3 FLAGSTONE DRIVE

STAFF REPORT #2

March 23, 2022

**Re: Town of Hudson Planning Board Review
3 Flagstone Drive Site Plan, 3 Flagstone Drive
Tax Map 222 Lot 14; Acct. #1350-990
Reference No. 20030249.2120**

SEWER & WATER UTILITY CROSSINGS

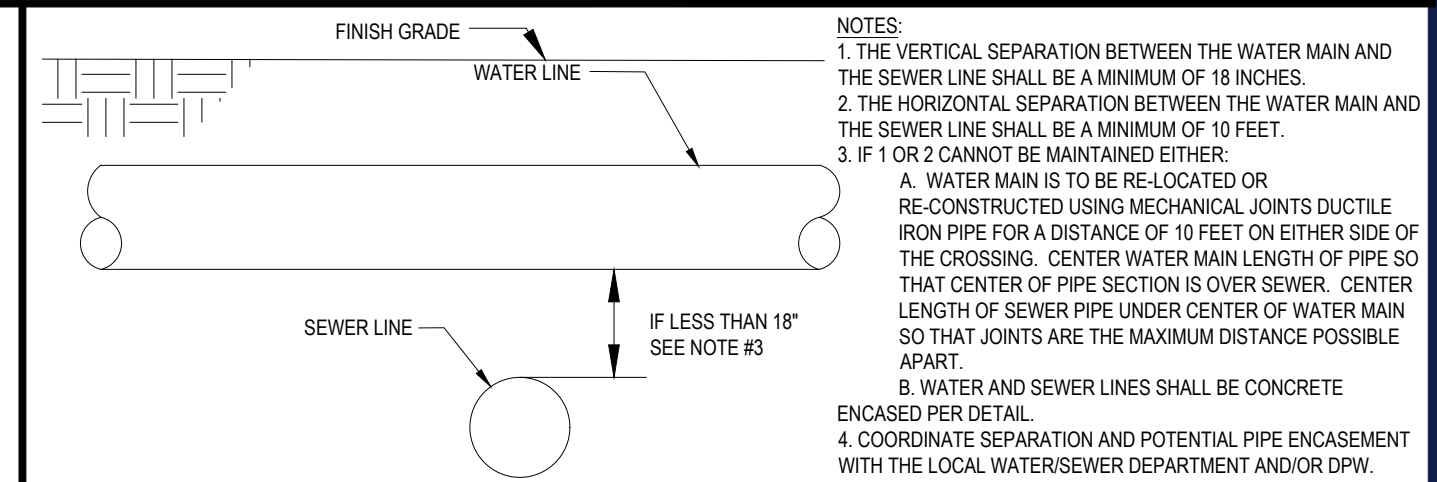
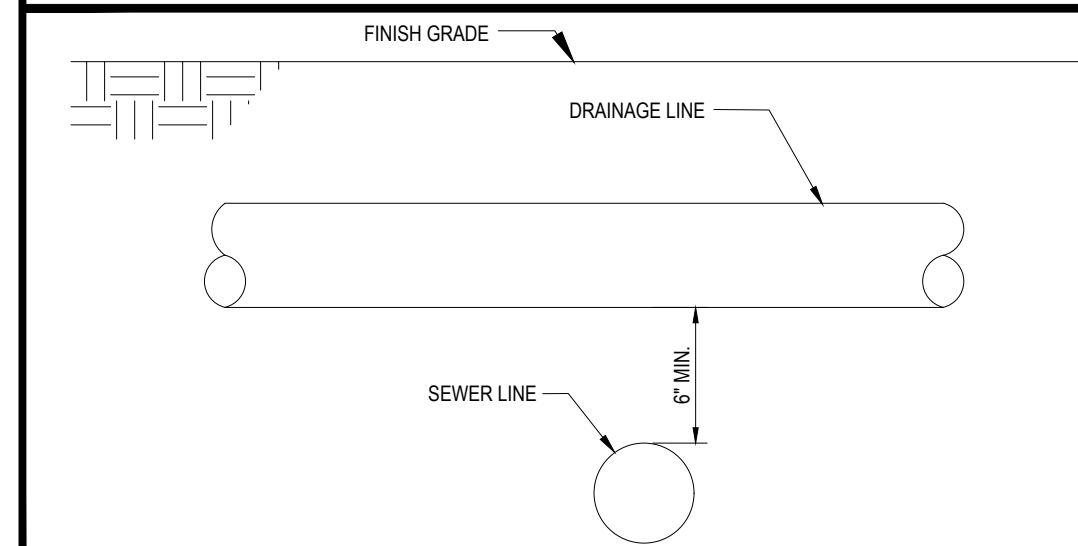
Comment #c. The applicant should provide a water/sewer crossing detail for the sewer service crossing the water main in Flagstone Drive and onsite, and crossing details for the service piping at the drain line in the driveway.

Response: **Utility crossing details have been added to sheet C-903 of the enclosed Proposed Site Plan Documents.**
